U.S. Department of Energy  
**Office of River Protection**

04-WTP-268

U.S. DEPARTMENT OF ENERGY (DOE), OFFICE OF RIVER PROTECTION (ORP)  
RESPONSES TO THE DEFENSE NUCLEAR FACILITIES SAFETY BOARD (DNFSB)  
CONCERNS

## **Responses to Issues Raised in July 21, 2004 Defense Nuclear Facilities Safety Board (DNFSB) Letter Regarding Waste Treatment and Immobilization Plant (WTP) Ventilation Systems Design**

Calc No.: 24590-PTF-S0C-S15T-00005, Rev. 0A

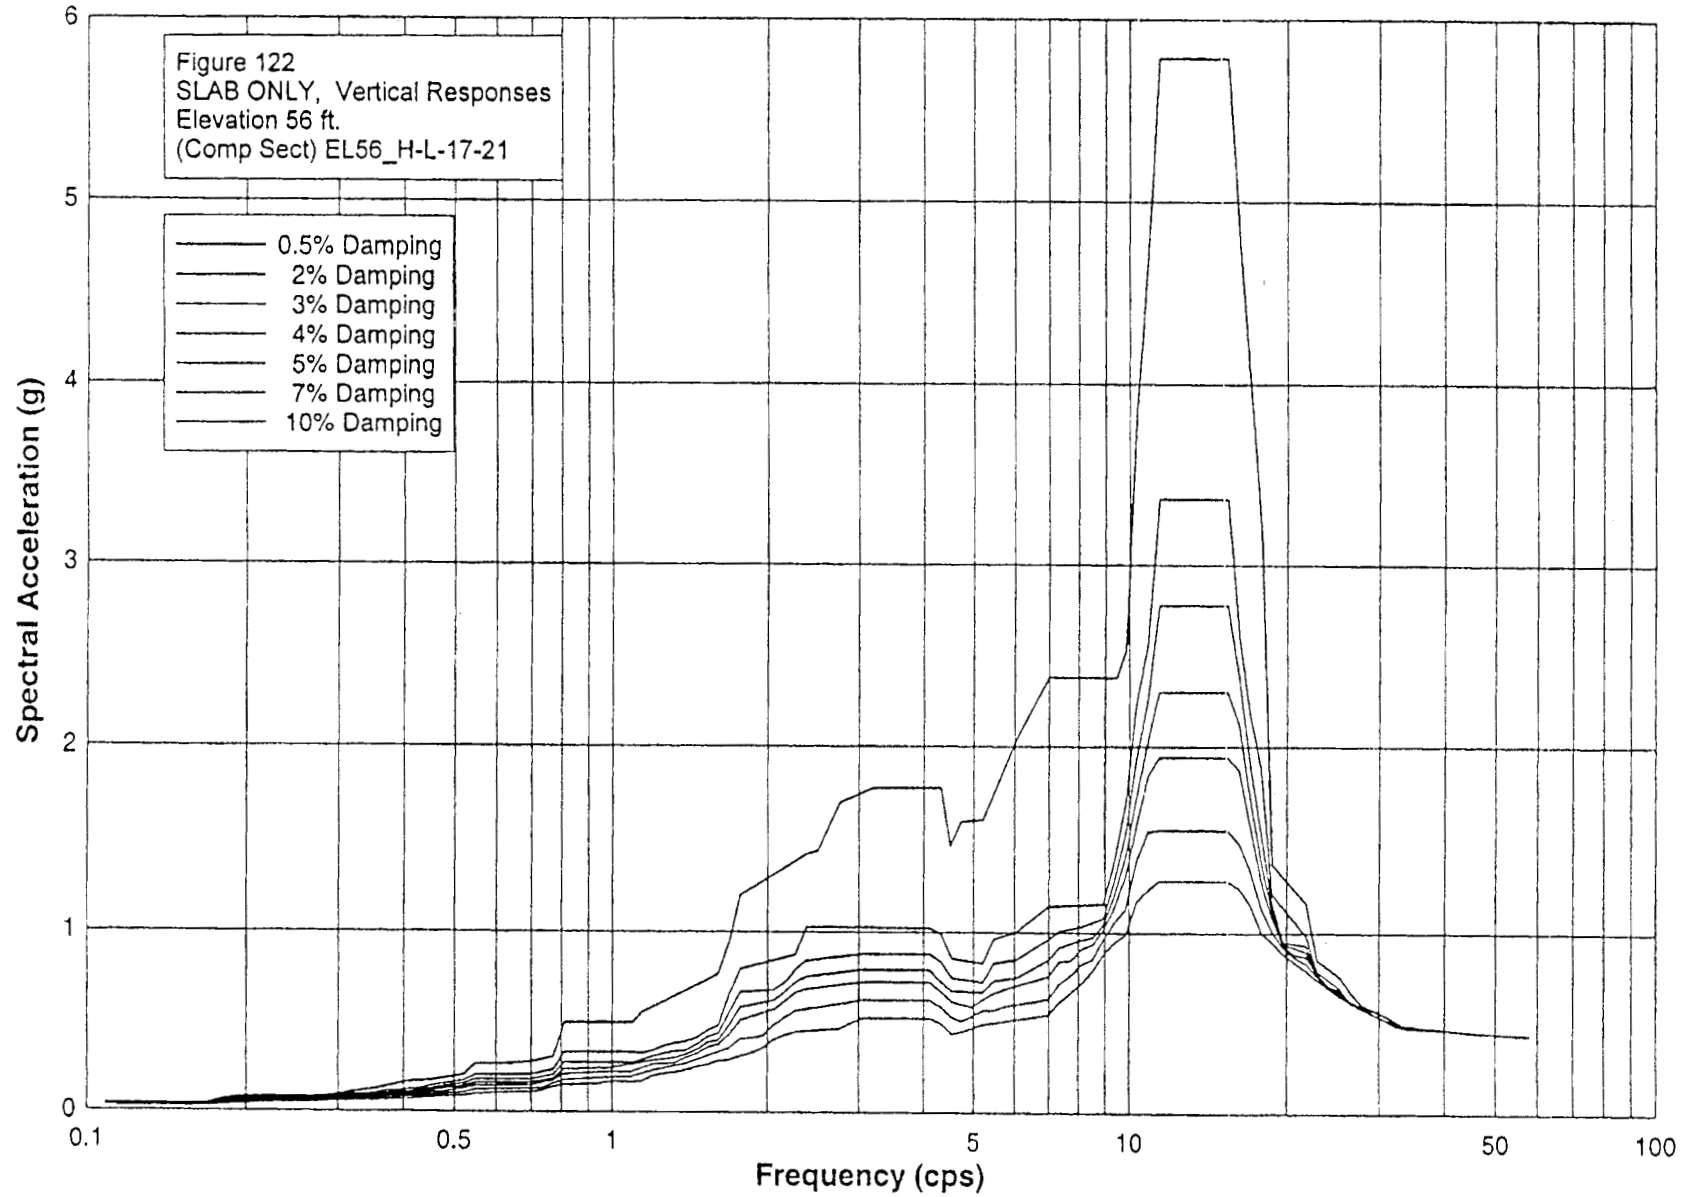
**WTP-04-281-02** The planned ventilation filter housing shaker table tests will use a bounding seismic spectra as input for the shaker table tests. The staff wants to review the bounding data for suitability.

**Response:** The WTP Project will not use bounding data for the PT and HLW facilities. The specific In-Structure Response Spectra (ISRS) curves for each facility will be used and separate testing for each facility will be conducted. The applicable curves, by elevation and column line, for the Remote Change HEPA Filter housings will be used which shows the expected frequencies and accelerations in the north/south, east/west, and vertical directions. The reason for applying the ISRS curves specific to each building and not using bounding data is as follows:

The Remote Change HEPA Filter Housings in the PT and HLW buildings will require separate testing for the following reasons:

- a) The housings are supported by steel platforms. Since the platforms are not rigid, they need to be simulated for testing. The platform configurations are different. Therefore, their simulations would be different, requiring separate testing.
- b) ISRS for PT and HLW buildings are different.
- c) It is likely that the external loads on the housings, e.g., connected ducts, in PT could be different from those in HLW.

Enclosed are the ISRS curves applicable to the Remote Change HEPA Filter housings in the HLW and PTF facilities.†
